ATTACHMENT B

MARKED-UP TECHNICAL SPECIFICATIONS

**HBPP Implementation of Generic Letter 89-01 Guidance**

Fig.V-1 Dosimeter Locations for Stations near HBPP

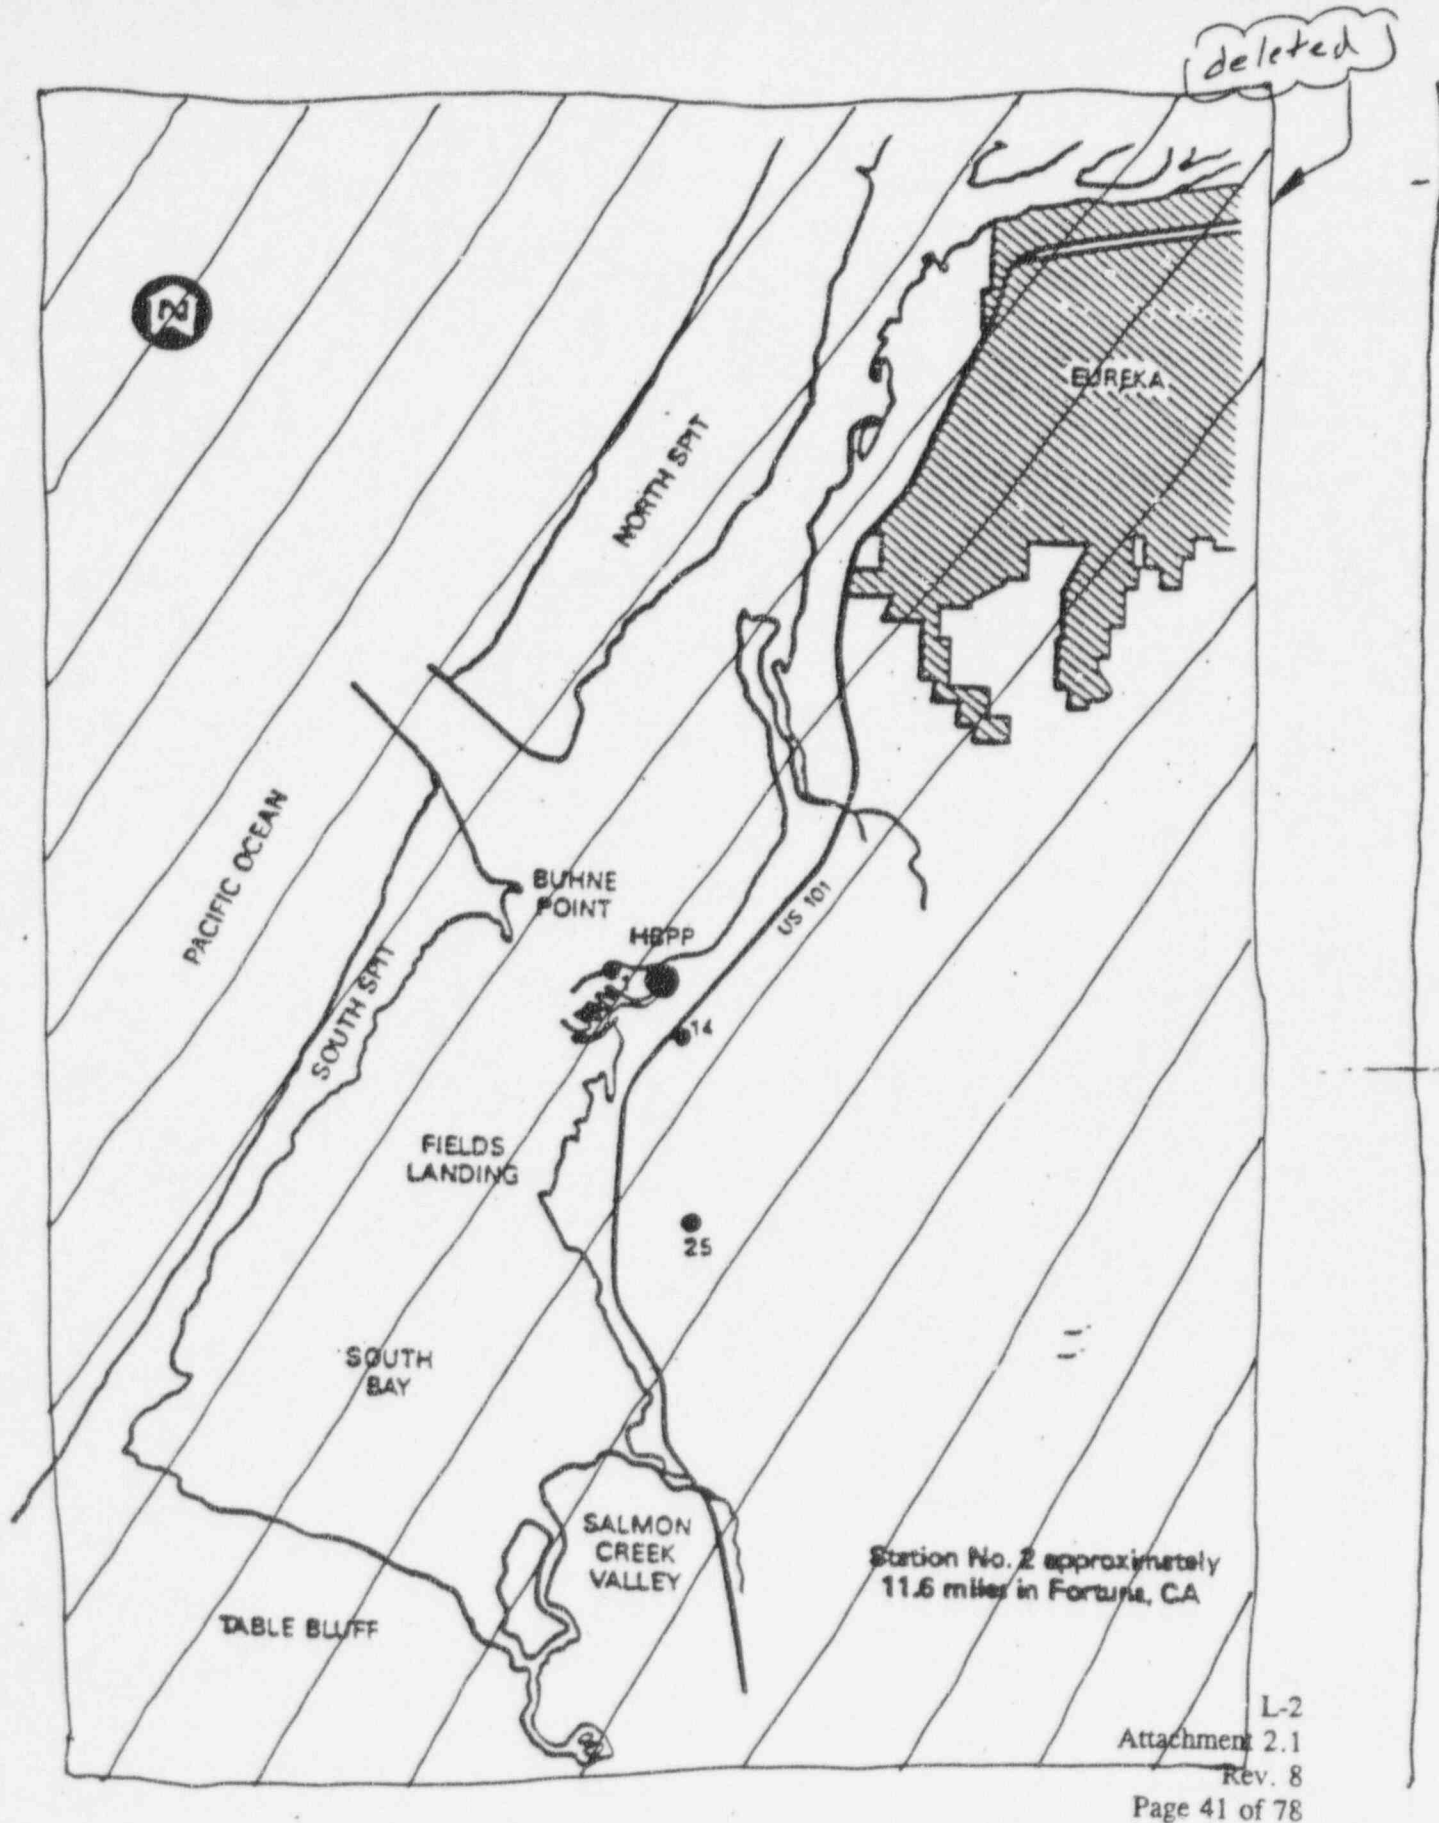
*Deleted*

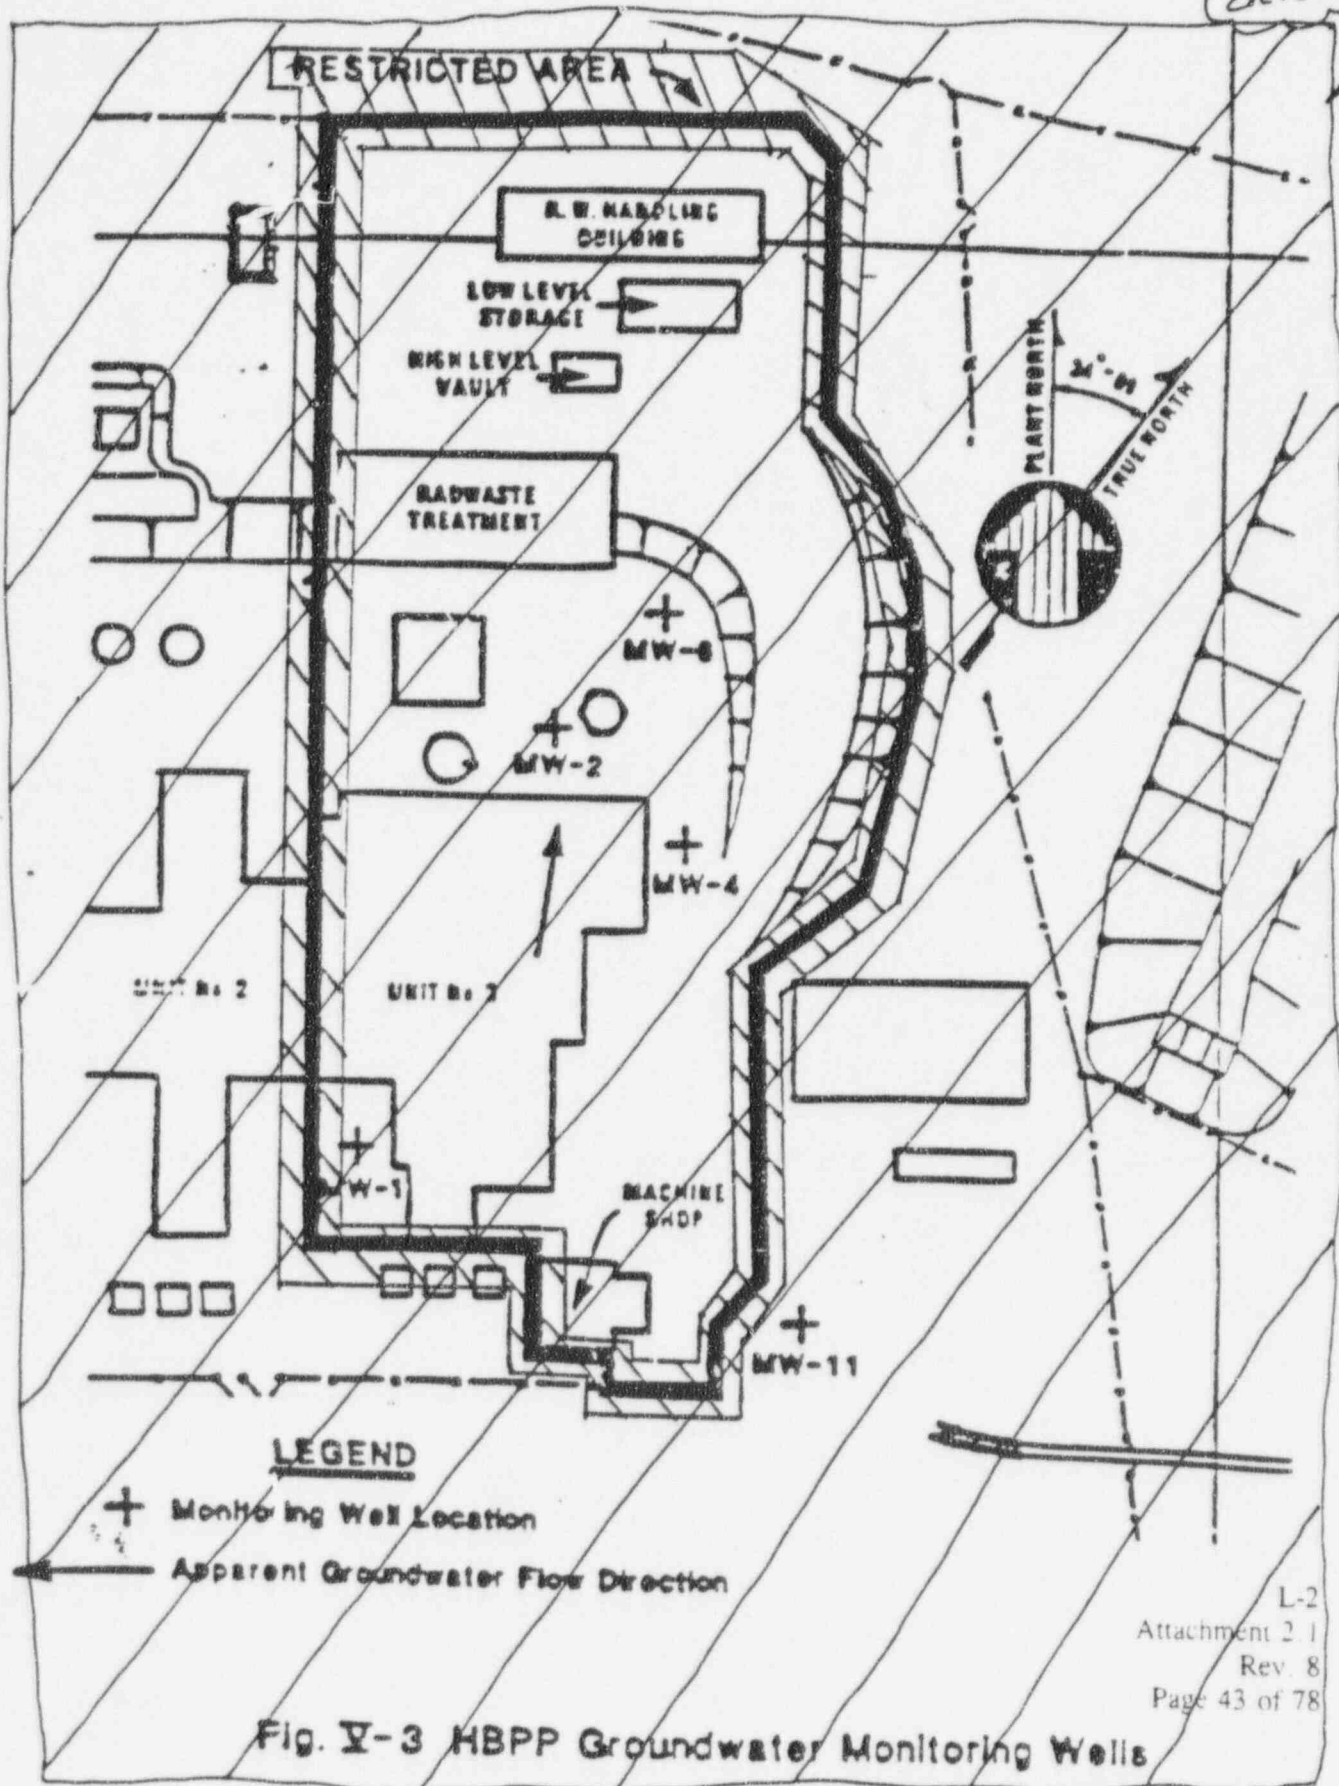
deleted
